STATE OF MAINE
DEPARTMENT OF TRANSPORTATION
16 STATE HOUSE STATION
AUGUSTA, MAINE 04333-0016

July 15, 2025
Subject: Bridge Replacement
WIN: 022382.00
Location: **Cumberland-Yarmouth**
Amendment No. 7

RELOCATED US 1 BRIDGE
INTERSTATE 295
CUMBERLAND-YARMOUTH CUMBERLAND COUNTY

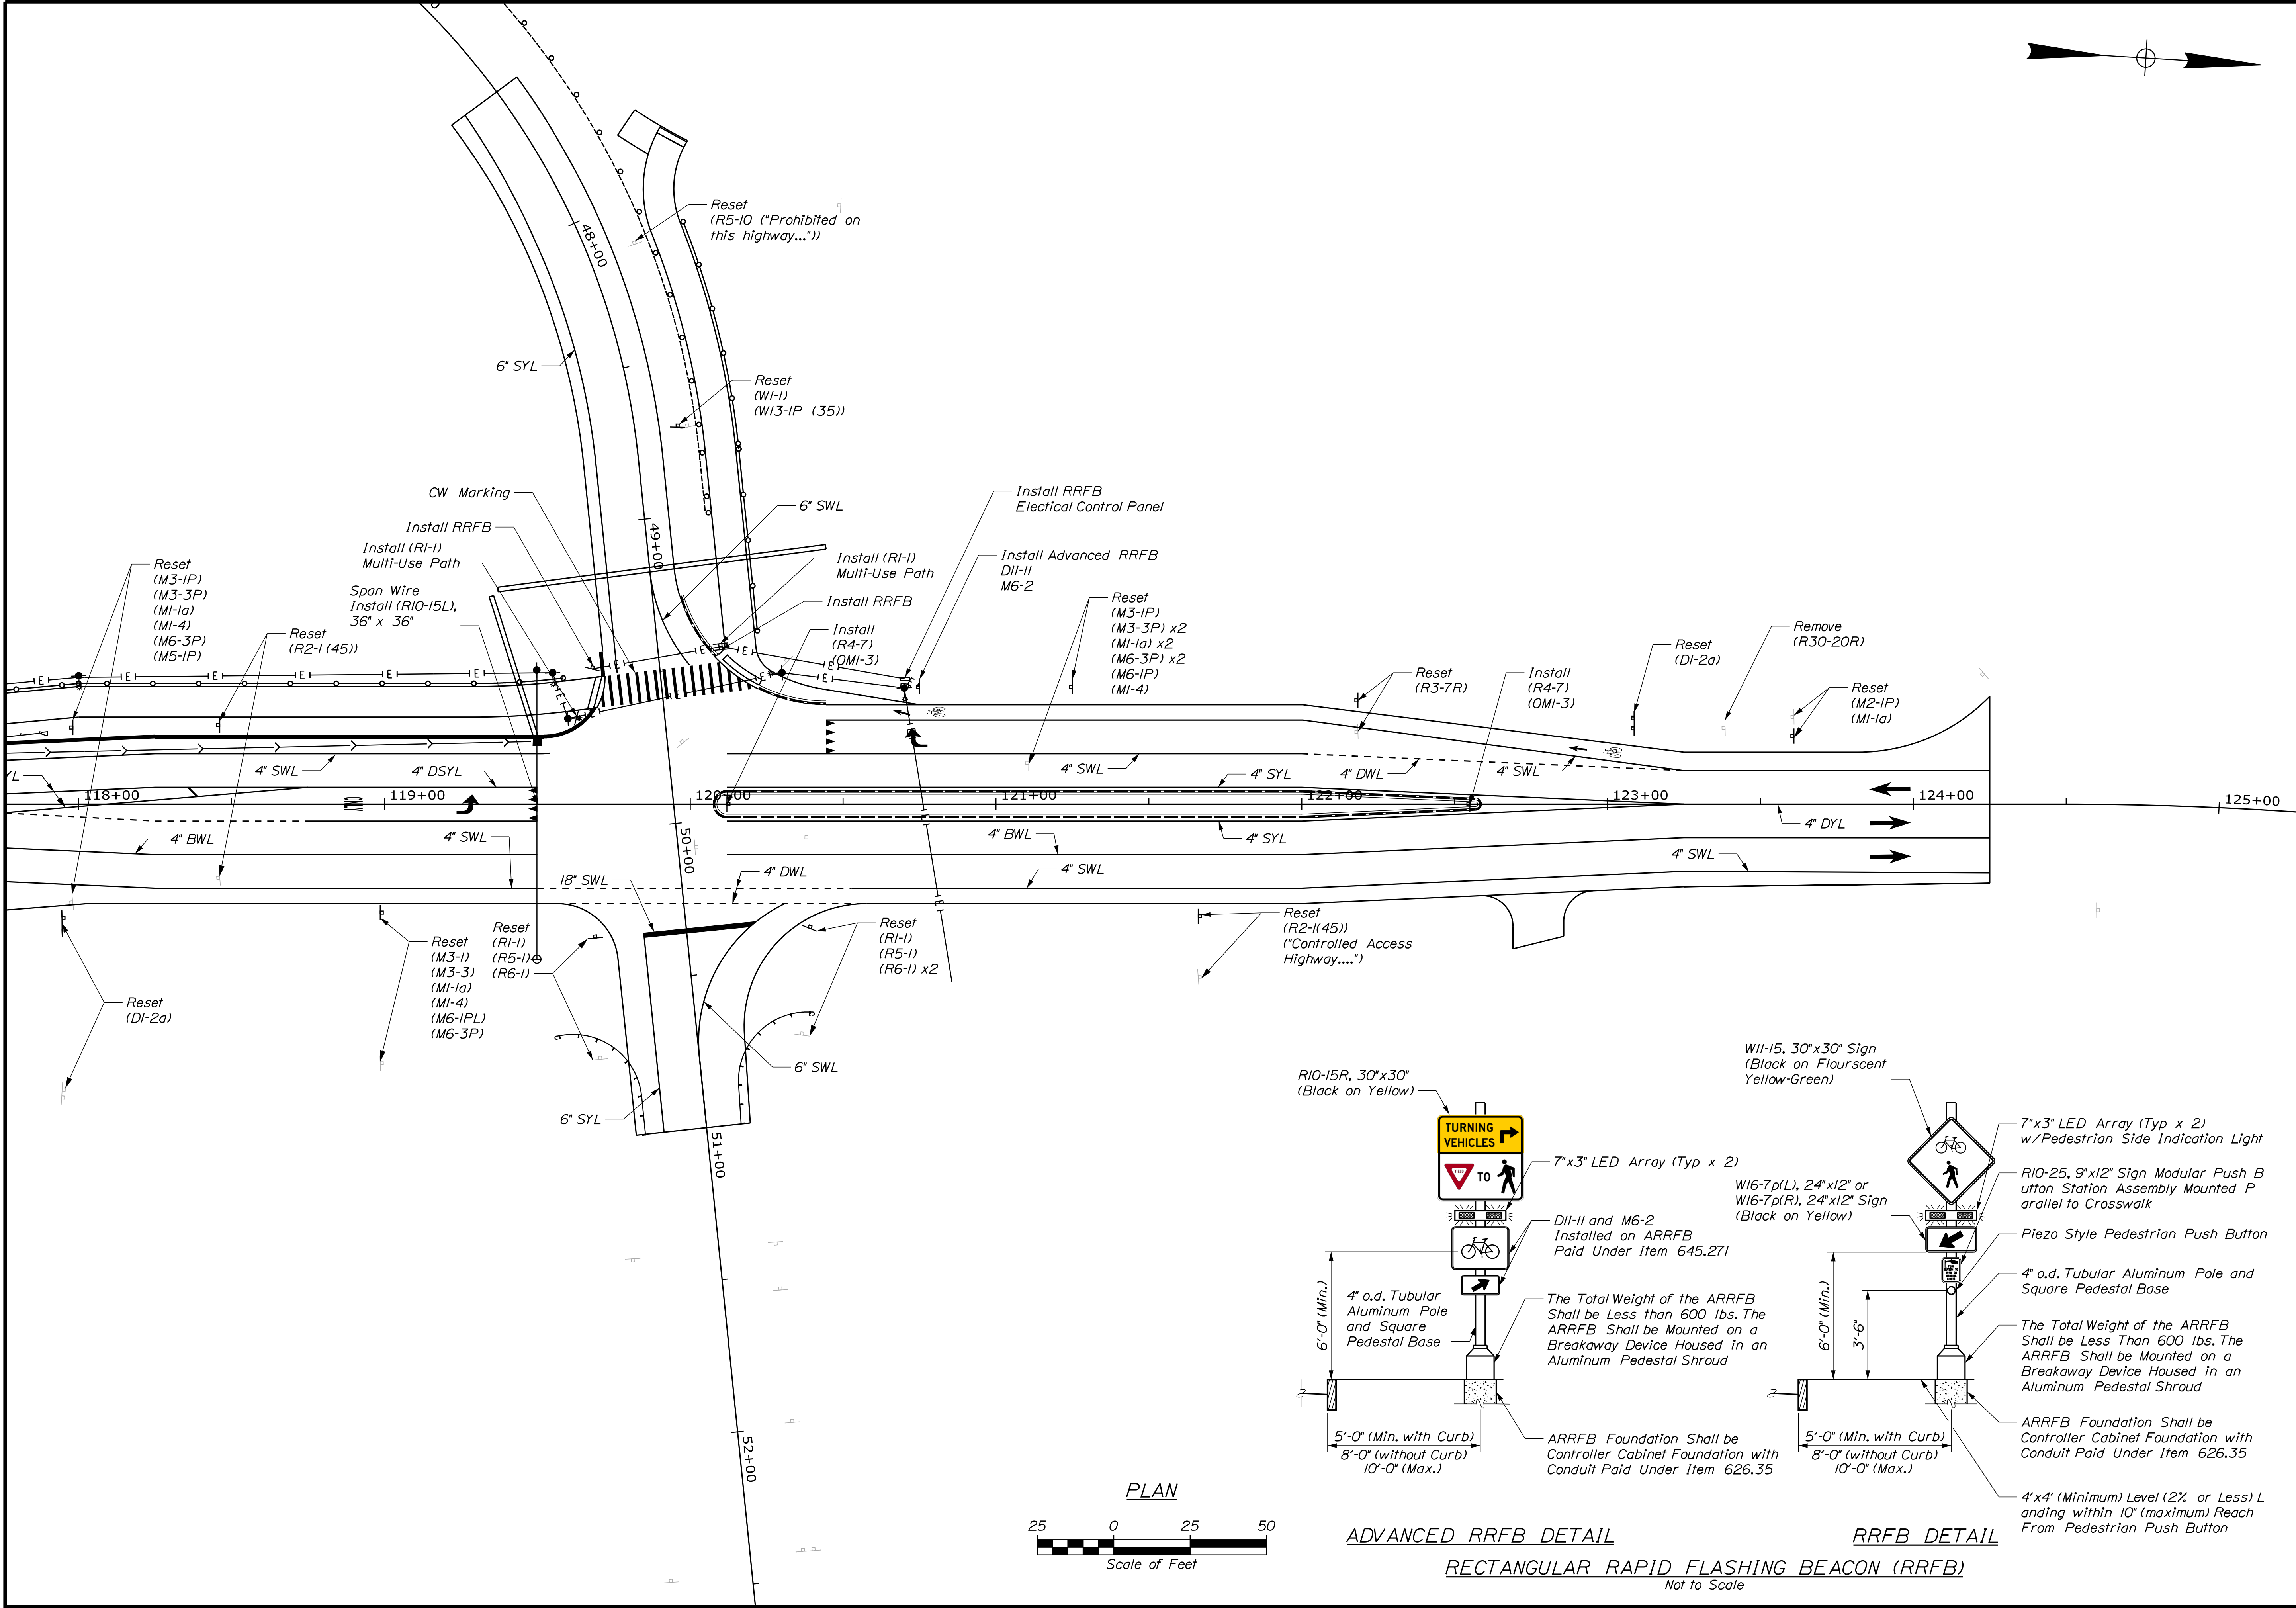
Question: At approximate station #119+00 the plans show a proposed pole & overhead span wire, provide details on what will be attached to the span wire. Will one wood pole for this span be paid for under item 643.97? Will the other end be attached to an existing utility pole?

Response: Two wood poles to be included in item 643.97, 44' LT and 51' RT. MUTCD Sign R10-15L, 36"x36" to be installed over left turn lane. Please see updated sheets 2 and 24.
